Seismic Walkdown Checklist (SWC)

Equipment ID No. I-1605-95-SPB Equip. Class¹² ZO

Equipment Description SOLID STATE PROT SYS CAR-TEN B

Location: Bldg. CONTROL Floor El. 220 Room, Area 165

Equipment ID No. 1-1605-Q5-SPE Equip. Class¹² 20

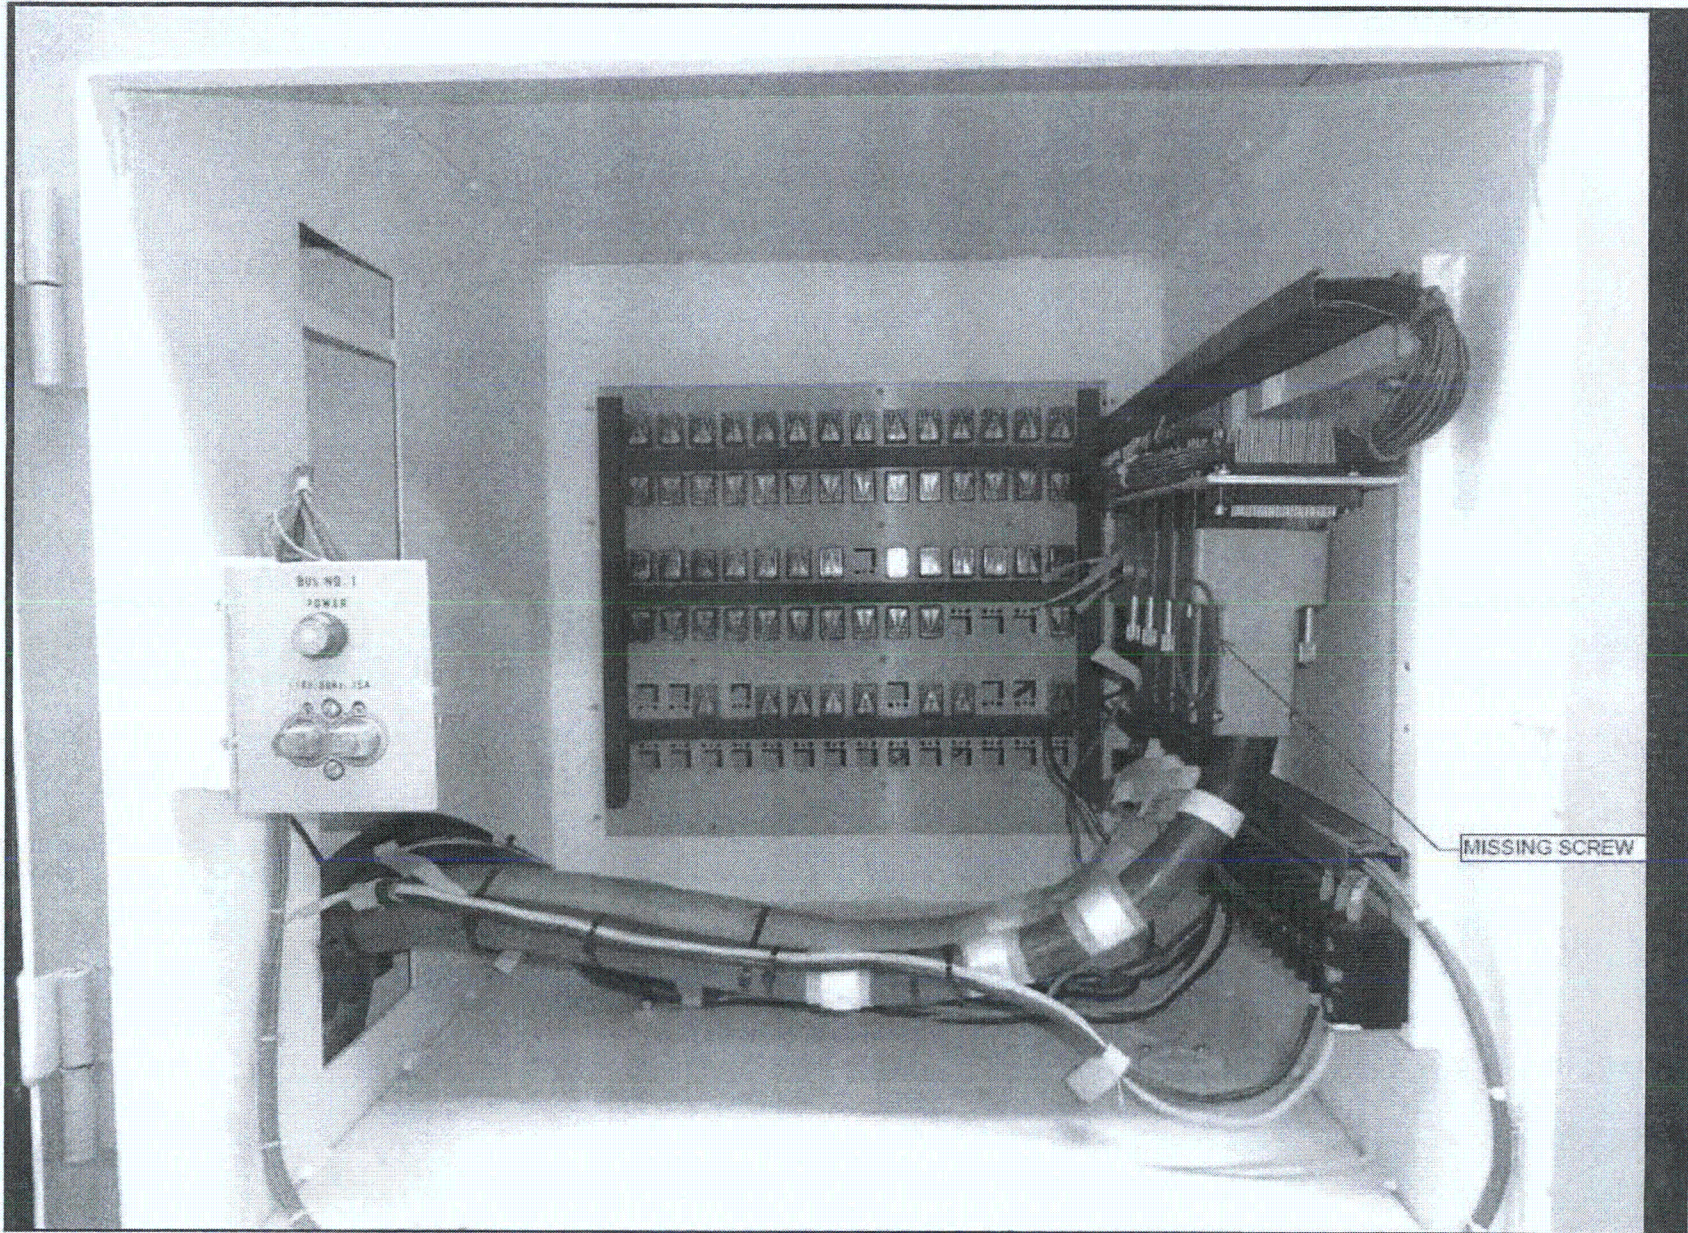
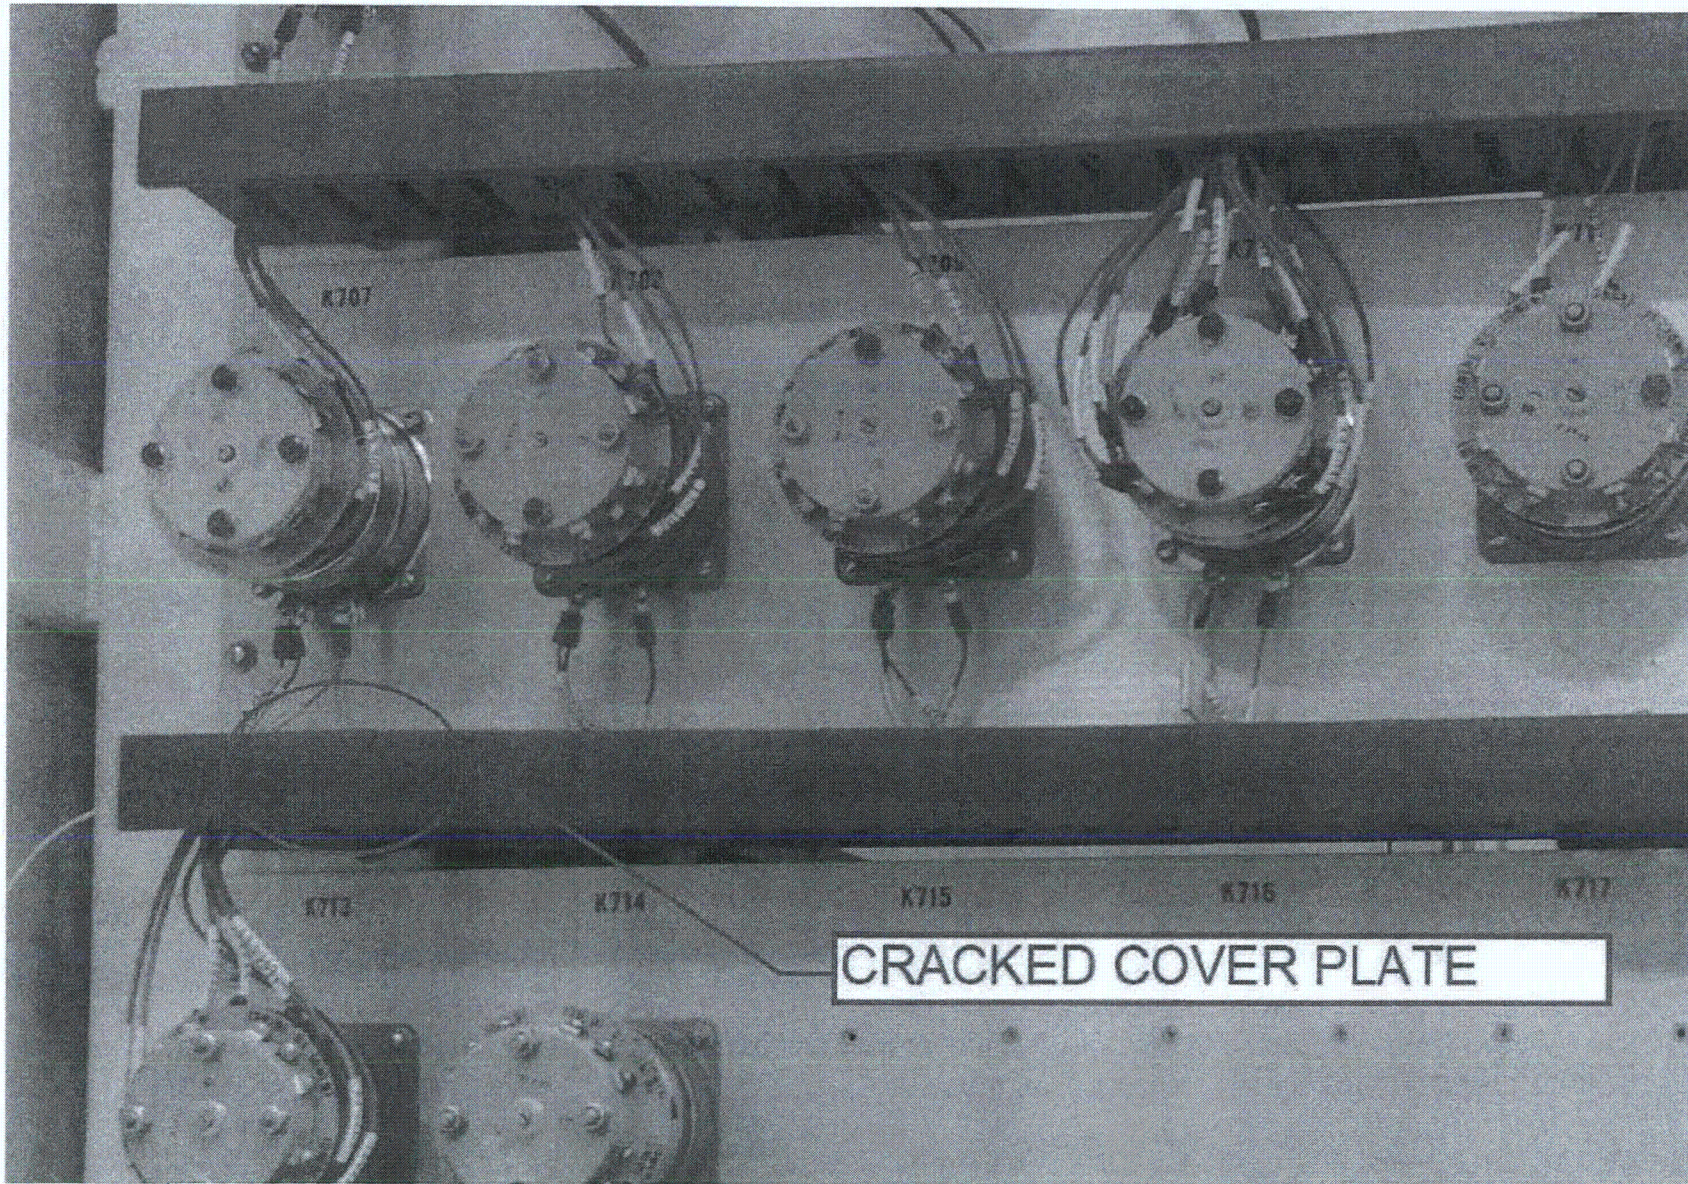
FOUND MISSING 1/2 LOOSE SCREWS USED TO SECURE PROTECTIVE COVERS, TERMINAL BLOCKS, 1/2 ALSO A CRACKED CABLE TRAY INSIDE THE CABINET. THE SEISMIC WALKDOWN TEAM JUDGED THAT THIS CONDITION DOES NOT REPRESENT A SEISMIC OR OPERABILITY CONCERN. THESE CONDITIONS WERE REPORTED UNDER CR 527627

Equipment ID No. 1-1623-DS-006A Equip. Class¹² 20

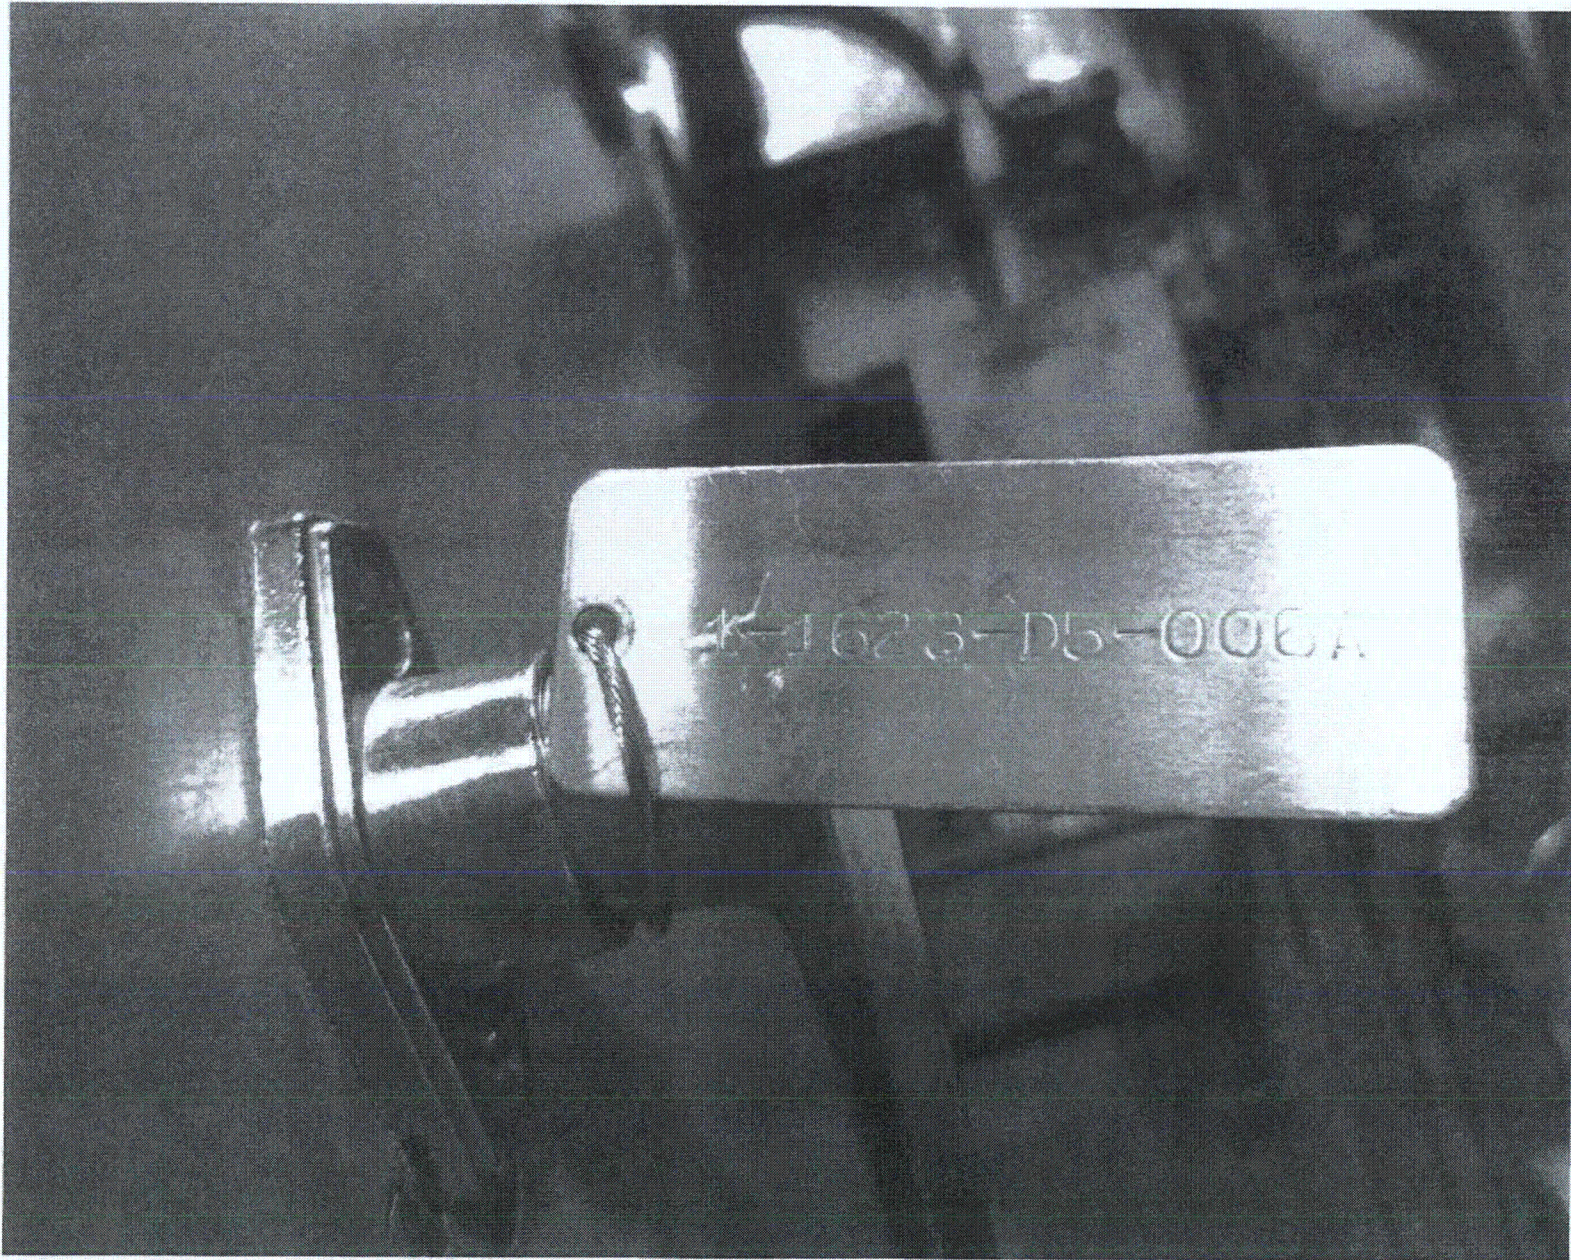
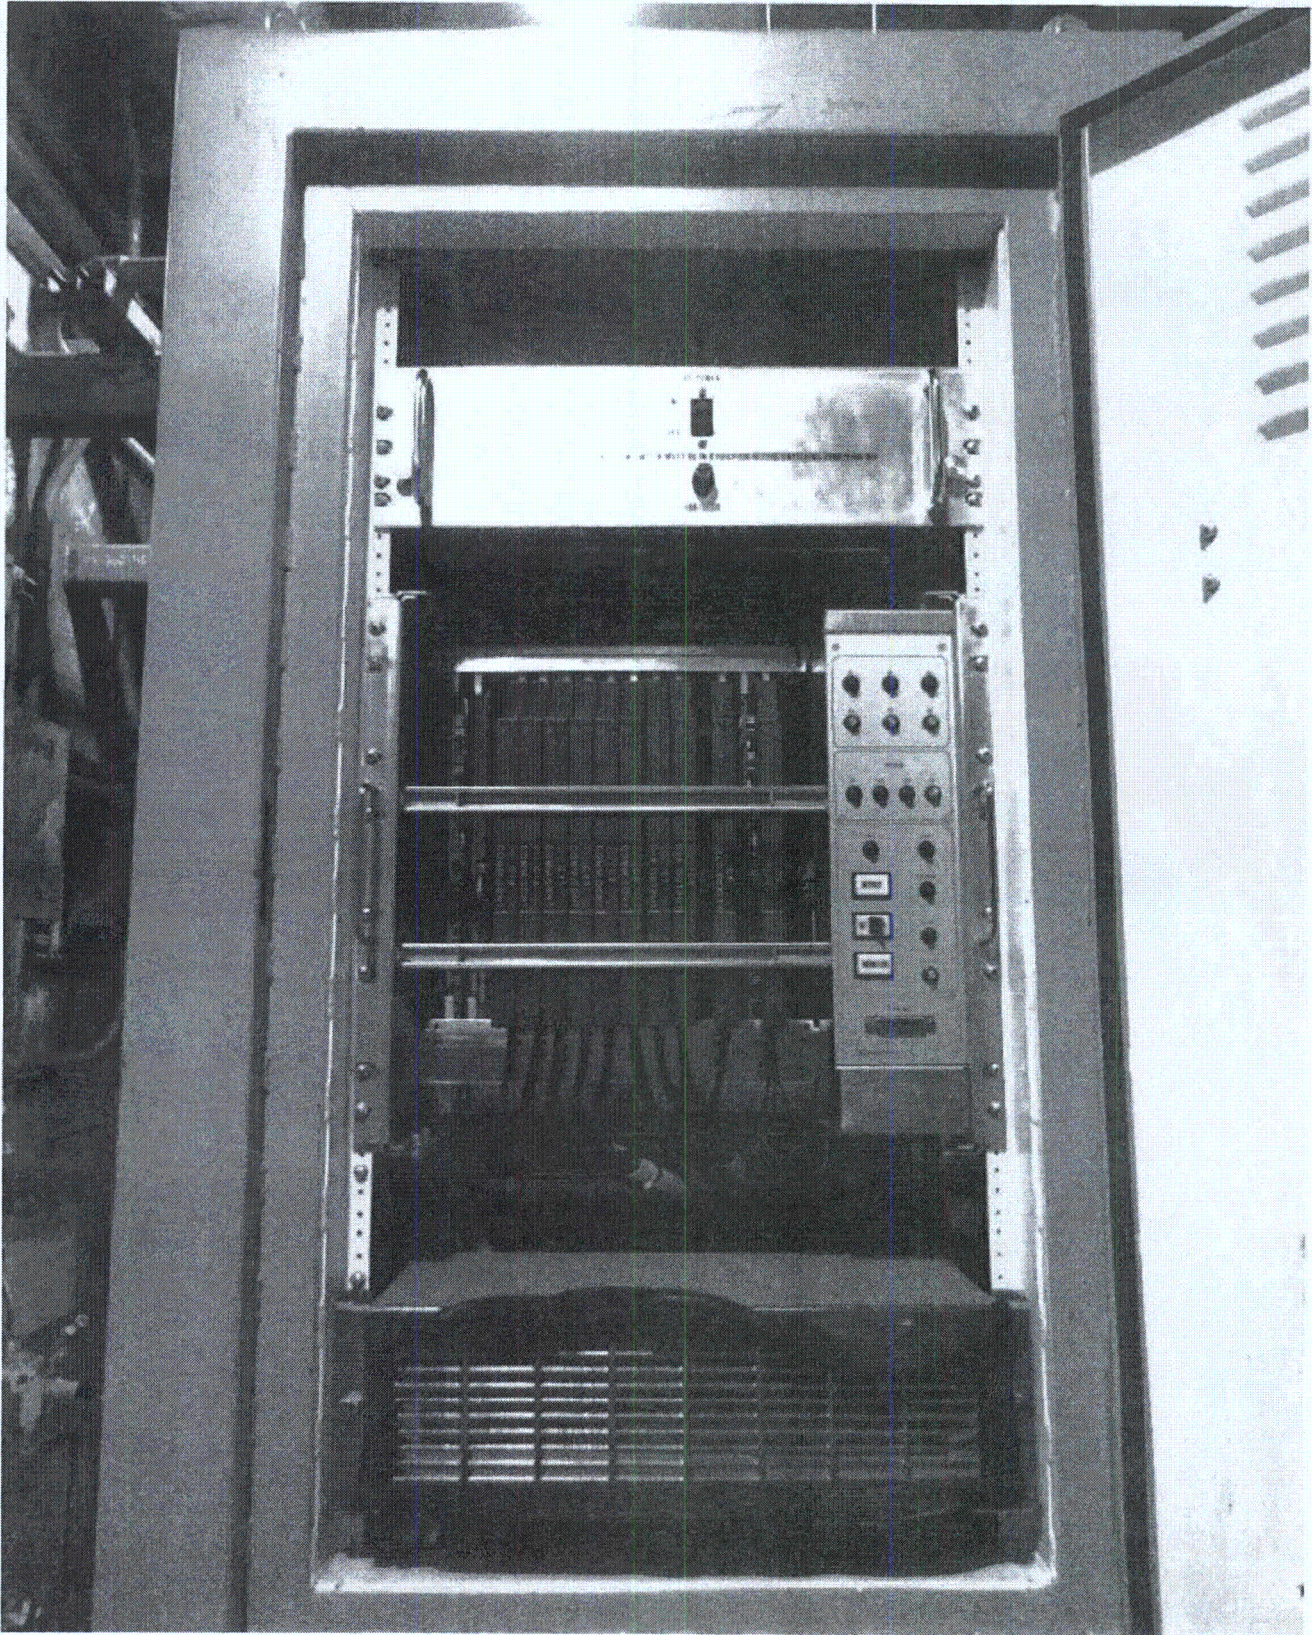
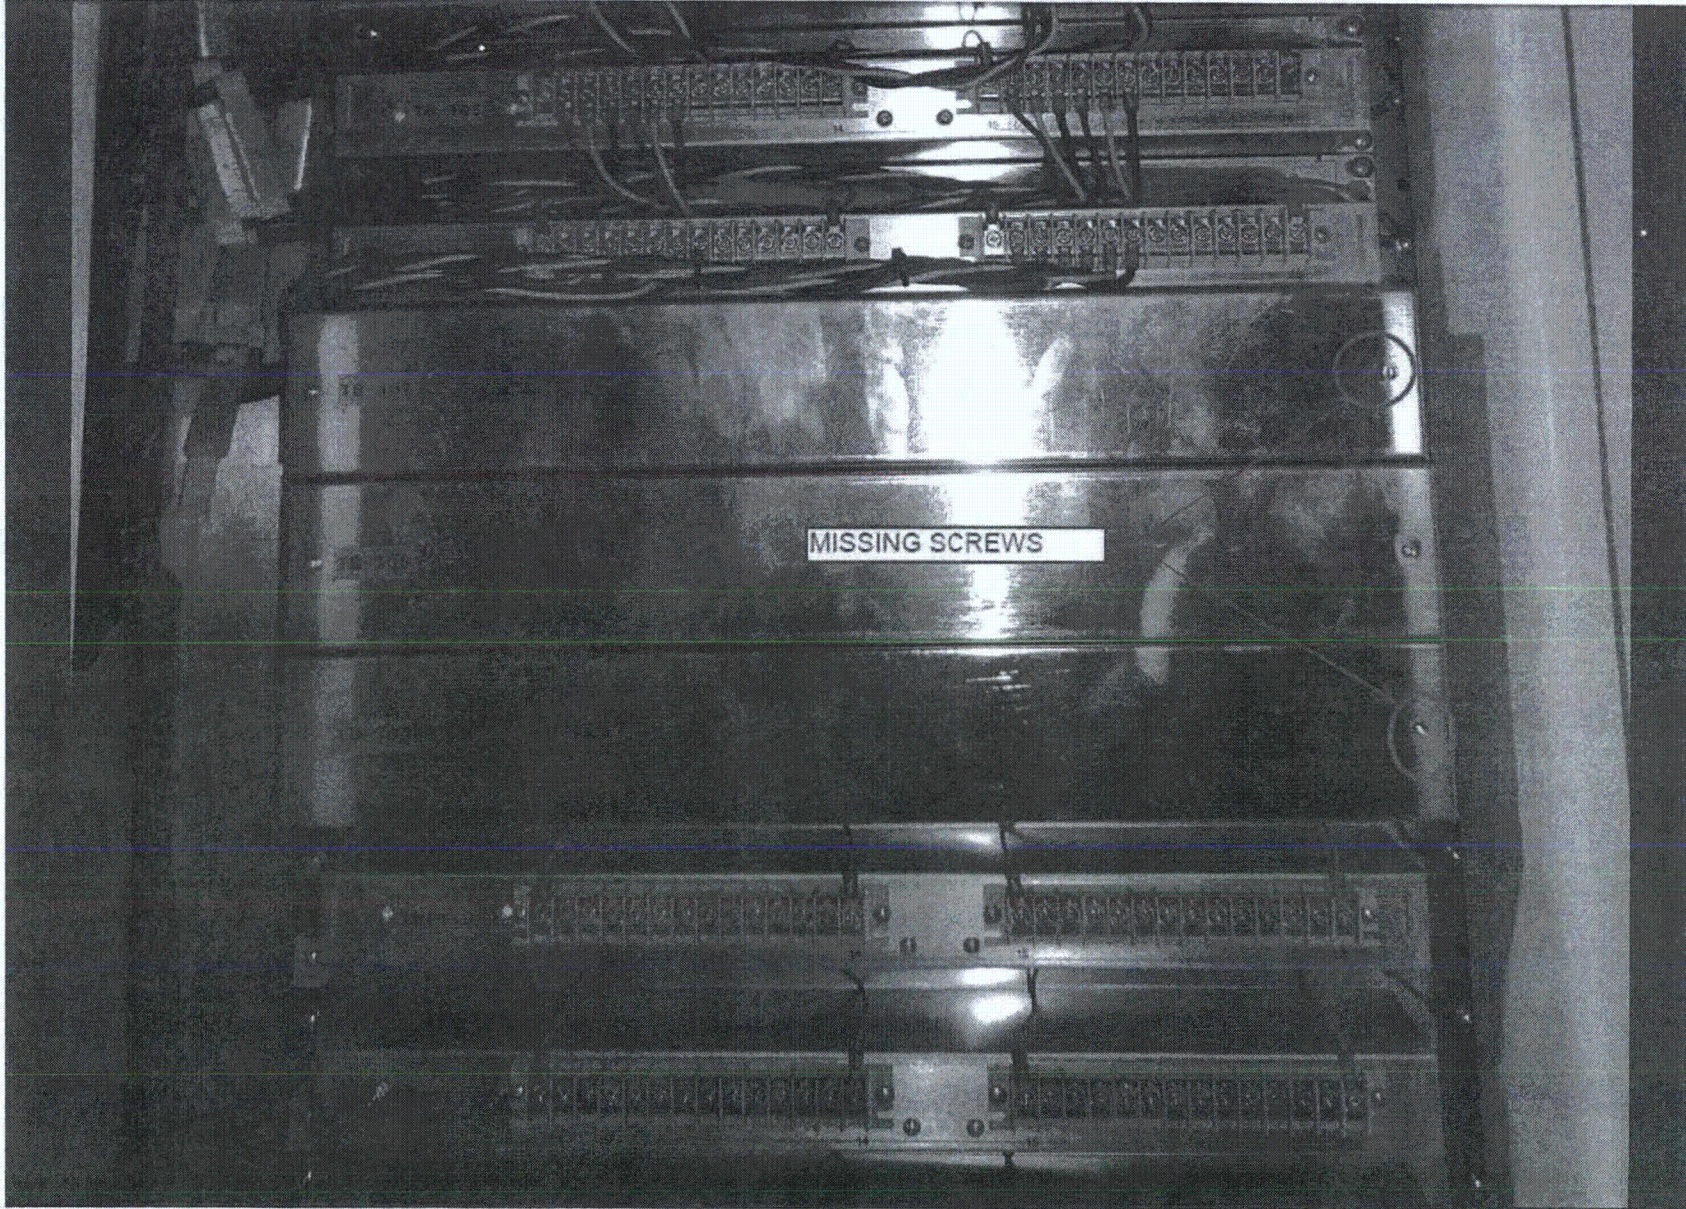
FOUND SOME SCREWS MISSING USED TO SECURE PROTECTIVE COVERS INSIDE THE CABINET. THE SEISMIC WALKDOWN TEAM JUDGED THAT THIS CONDITION DOES NOT REPRESENT A SEISMIC OR OPERABILITY CONCERN. THIS CONDITION HAS BEEN REPORTED THROUGH CR 527695
